KX3 KIT ASSEMBLY MANUAL ERRATA

Rev. G6-1, June 25, 2015

MAKE THESE CHANGES TO YOUR REV G6 MANUAL BEFORE BEGINNING ASSEMBLY

Figure 35. Preparing the Thermal Pad.

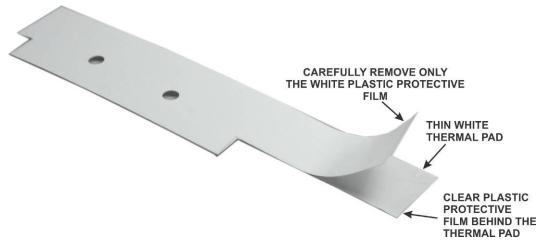
1. Pages 26 and 27: The following replace Figures 35, 36 and 37 with the following. Make a note in the manual to refer to this errata. The new figures show the proper installation of the new thermal pad in your kit.
